No: 26-019

DAUPHIN COUNTY SUBDIVISION/LAND DEVELOPMENT REVIEW REPORT

Plat Title: Lenny Radle Estate, Randall S Radle & Rebecca J Weaver

Project Description: Proposed subdivision for side yard addition

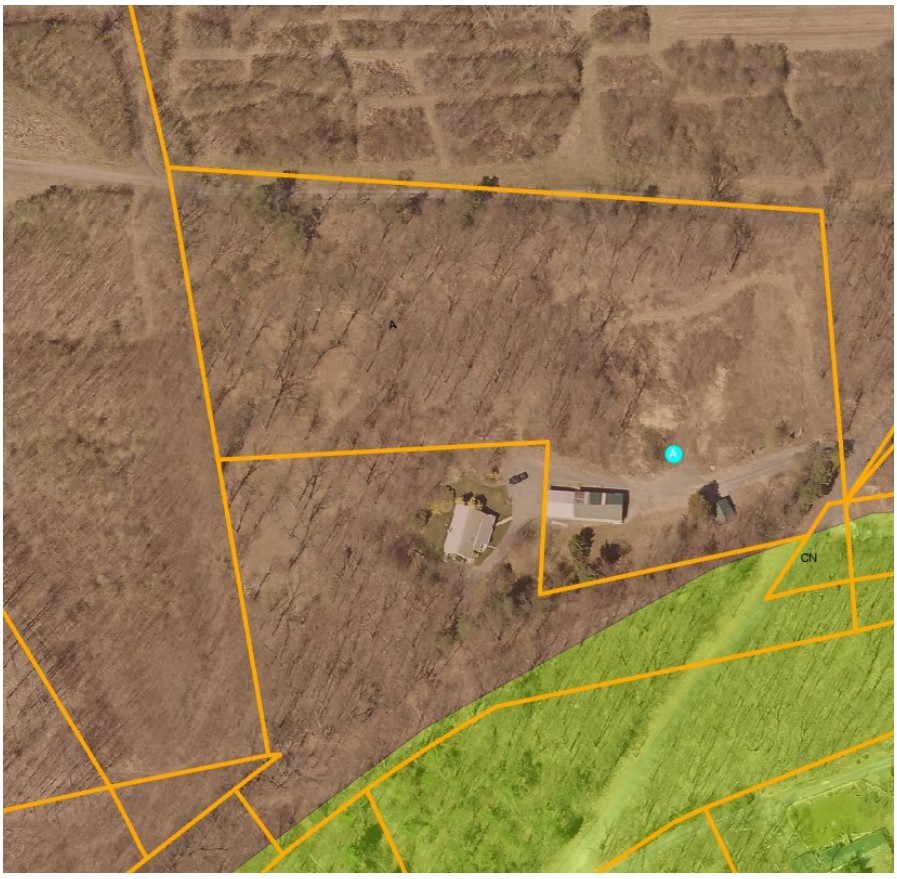
10. When the subdivision of lots is proposed, no accessory building may be erected in front of the principal building. (S&LDO §22-404.1.H.1) There is an existing garage and shed located in Area 1B, which will be located in the front yard of existing parcel 66-010-108.

PRELIMINARY/ FINAL SUBDIVISION PLAN FOR

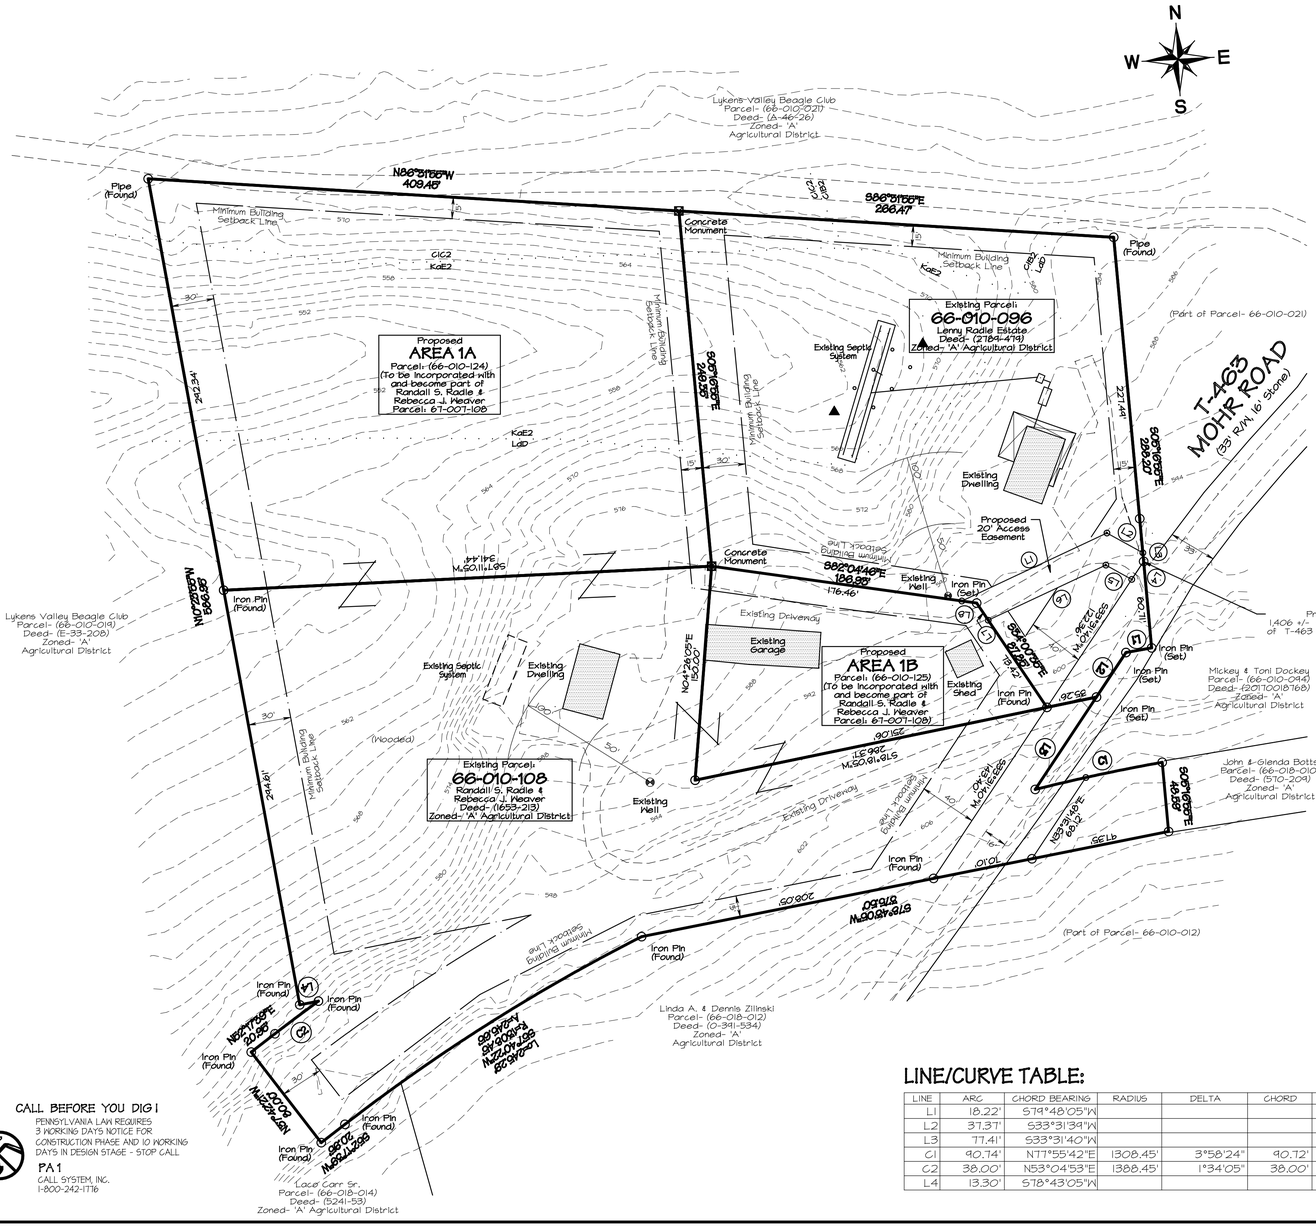
1. The applicant has requested a waiver of Preliminary Plans. (S&LDO §22-304)
2. The designation of the plan as a final plat is required to be displayed. (S&LDO §22-307.1.A). The application to the DCPC indicates this as a Final Plat for Subdivision. This should be corrected to reflect a Final Plat for Subdivision on the plan. For the purpose of this review, this was reviewed as a Final Plat for Subdivision.

3. All easements are required to be shown. (S&LDO §22-301.1.B) This would include utility easements, which are not displayed.
4. A number to identify each lot/site is required. (S&LDO §22-307.1.E)

5. Locations and descriptions of survey monuments are required to be displayed. (S&LDO §22-307.1.H)
6. A final Erosion and Sedimentation Plan is required. (S&LDO §22-307.1.P.3) It is noted that there is no earth-moving activity with this plan.

7. Sight Distances must be provided. (S&LDO §22-401.8)
8. Sidewalks and Handicapped Access. Sidewalks shall generally be required for residential and commercial areas and shall not be less than 4 feet wide. (S&LDO §401-17). The applicant has requested a waiver for this requirement.

1. The Plan's Site data and Township Zoning Map indicate that parcel 610-010-108 is zoned Agricultural and Conservation; however, the plan does not display the boundary of the Conservation District for the lot. This is required to be displayed.

2. Percentage of lot coverage is not shown and should be provided to ensure compliance with ZO §27-407.
3. Accessory structures shall not exceed an area of 1,000 square feet. (ZO §27-1201). The existing garage located in Area 1B appears to exceed more than 2,000 square feet in size, according to measurements taken with GIS technology. This should be reviewed by the Zoning Officer for compliance.

4. Accessory buildings may be erected within one of the side yards or within the rear yard. (ZO §27-1202.4.C) The existing shed and garage located in Area 1B would be located within the front yard of reconfigured parcel 66-010-108. This should be reviewed by the Zoning Officer for compliance.

1. The proposed 20' access easement displays a shared driveway access with lot 66-010-096 onto T-463 (Mohr Road). A maintenance agreement for the proposed shared access easement should be provided to the Township for review.
